Access Compliance Report

Public Rights-of-Way

Intersection ID: 31684	Main Street: HYACINTH_CT	Cross Street: WILLIE_WORRELL_DR	Location: SW
ADA ID: E1DF705E3CF7	Ramp Type: PerpDiag	Initial Pass/Fail: Fail	Overall Compliance: No
Severity Score: 55			
Codes/Mitigation Info/Possible Solution		Field Measurements/Component Compliance

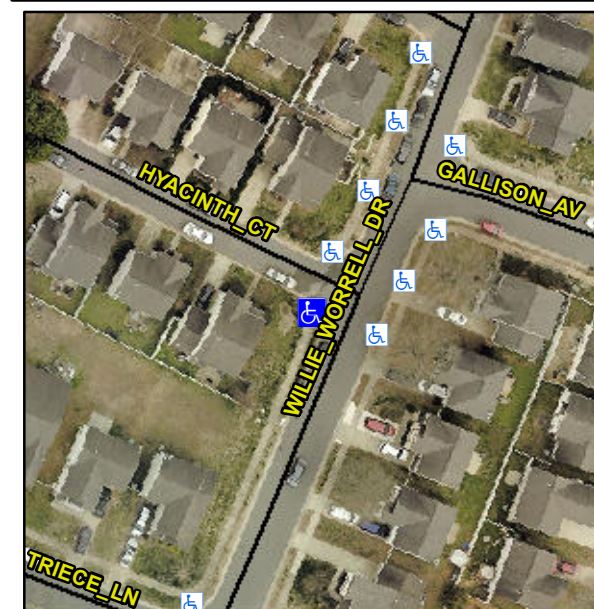
Not Found, R304.5.1, R304.2.2, R304.5.3

Compliance	Description	Data	Compliance	Description	Data
N/A	Ramp Length (in)	47.0	No	Ramp Slope (%)	10.5
No	Ramp Width (in)	32.0	No	Ramp XSlope (%)	7.2
N/A	Flare Type LT	N/A	N/A	Flare Type RT	N/A
N/A	Flare Slope LT (%)	N/A	N/A	Flare Slope RT (%)	N/A
N/A	Flare Traversable LT?	N/A	N/A	Flare Traversable RT?	N/A
N/A	Landing Length (in)	N/A	N/A	DWS Provided?	N/A
N/A	Landing Width (in)	N/A	N/A	DWS Contrast?	N/A
N/A	Landing Slope (%)	N/A	N/A	DWS Length (in)	N/A
N/A	Landing X Slope (%)	N/A	N/A	DWS Full Width?	N/A
N/A	Landing Curb? (Y/N)	N/A	N/A	DWS Offset (in)	N/A
N/A	Shared Landing?	N/A			
N/A	Gutter Ponding?	N/A	N/A	Gutter Slope (%)	N/A
N/A	Gutter Lip Ht (in)	N/A	N/A	Gutter X Slope (%)	N/A
N/A	Painted X Walk1?	No	N/A	Painted X Walk2?	No
	X Walk 1 Direction	To SE		X Walk 2 Direction	To NE
N/A	X Walk 1 Width (in)	N/A	N/A	X Walk 2 Width (in)	N/A
	X Walk 1 Slope (%)	5.1		X Walk 2 Slope (%)	2.6
	X Walk 1 X Slope (%)	5.7		X Walk 2 X Slope (%)	2.0

Remove & Replace Curb Ramp With Two New Directional Ramps or Equivalent.
